VRP Project #: **15017**
Brownfield Site: Yes No
Report Date: **5-4-15**
Page 1 of 5

OFFICE OF ENVIRONMENTAL REMEDIATION
VOLUNTARY REMEDIATION PROJECT
SITE VISIT/INSPECTION REPORT

FREEDOM INDUSTRIES
 1015 BARLOW DRIVE, CHARLESTON, WEST VIRGINIA
 OH003003.0001

PROPOSED STORM WATER COLLECTION
 TRENCH LAYOUT

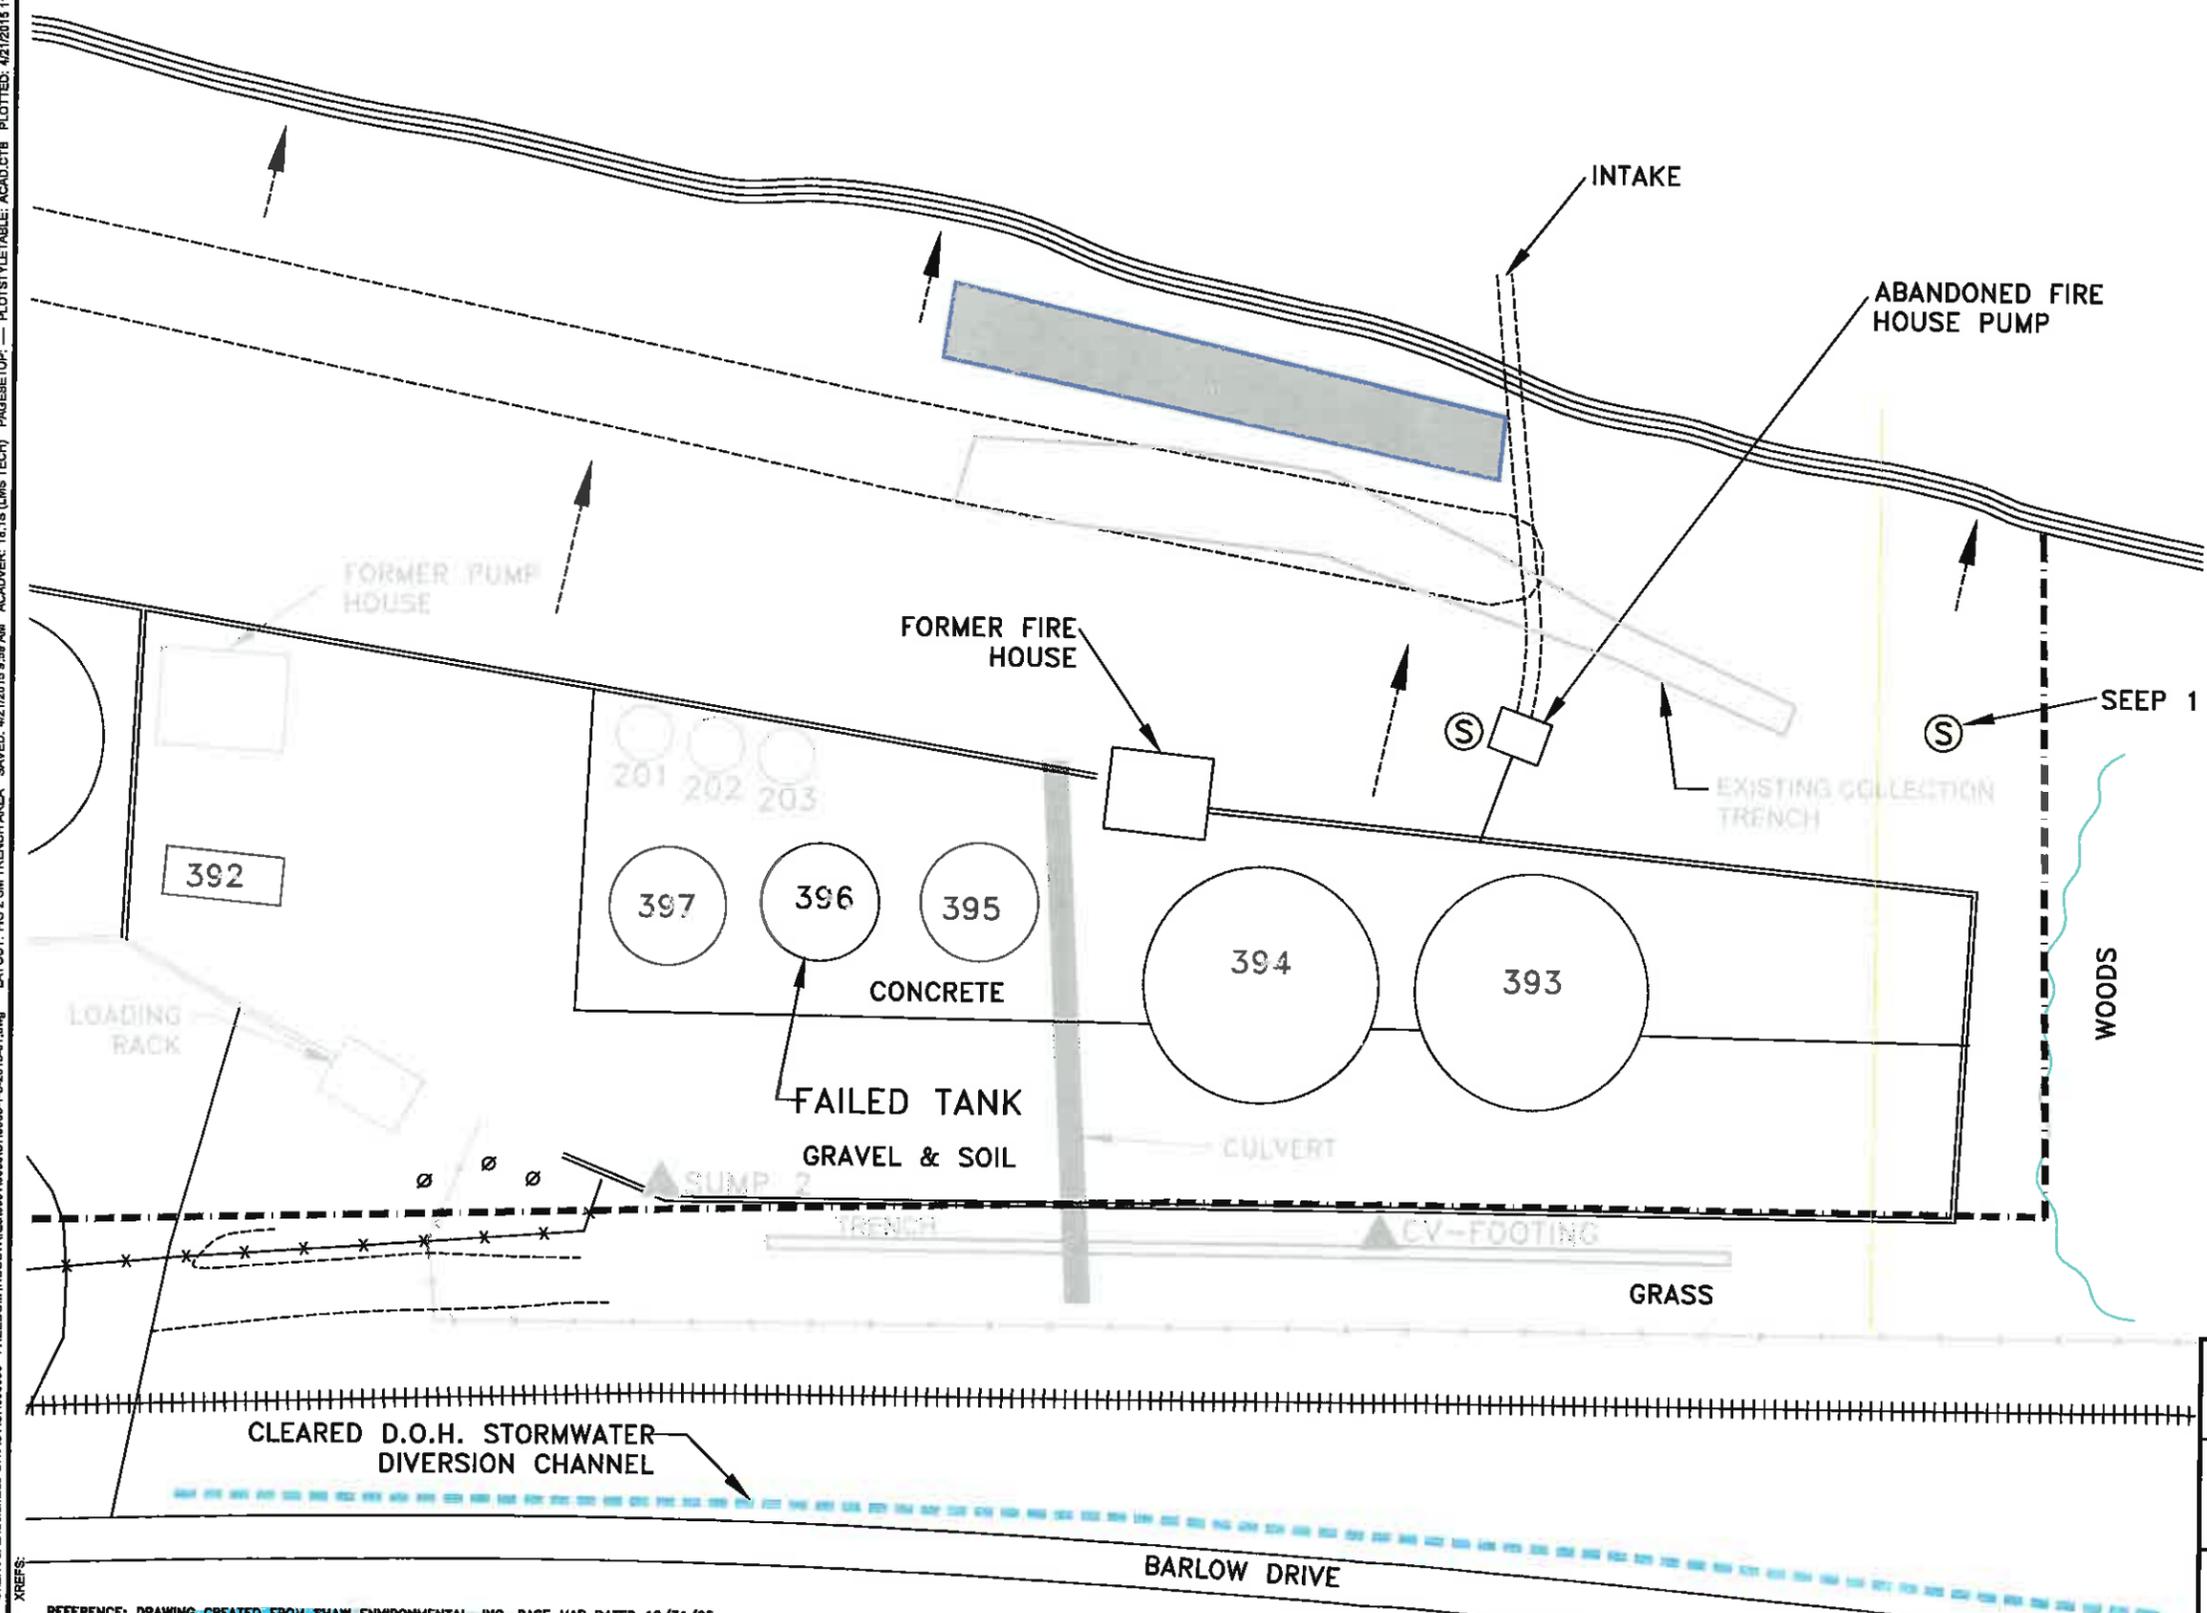
We first walked to the spill area to check on the excavation in the former fire house area. An MCHM odor was present and the water level in the excavation was lower than on the previous site visit. A fairly heavy sheen was obvious on the water and staining was present on the walls of the excavation. Climbing down to the lower terrace/collection trench area, significant erosion of the slope below the excavation area was visible. Once down on the lower terrace, an MCHM odor was noticed around the sump areas. The collection trench itself appeared to extend to the western edge of the lower terrace, with no room for an additional trench downgradient of the existing trench on the lower terrace. In addition, the slope from the terrace to the river is much too steep for any additional trench installation. WVDEP/OER and OEE agreed on the following concerns: 1. Any attempt to install an additional trench

downgradient on the lower terrace would breach the existing trench; 2. Any attempt to install a trench below the terrace would likely cause the terrace and trench to collapse, and possibly cause mobilization of the cobble fill area; 3. Removal of existing vegetation to install the trench below the terrace would cause greater instability; and 4. Any trench installed below the terrace would likely be inundated by the river.

1. Former fire house area excavation - note sheen on water and staining on walls of excavation (looking north).
2. Looking north across excavation to northern end of site
3. Stormwater flow path from former MCHM/PPH tank area to fire house excavation (looking northeast).
4. Looking south at fire house excavation (note heavy sheen on water)
5. Close-up of erosion below excavation
6. Looking southwest at erosion below excavation.
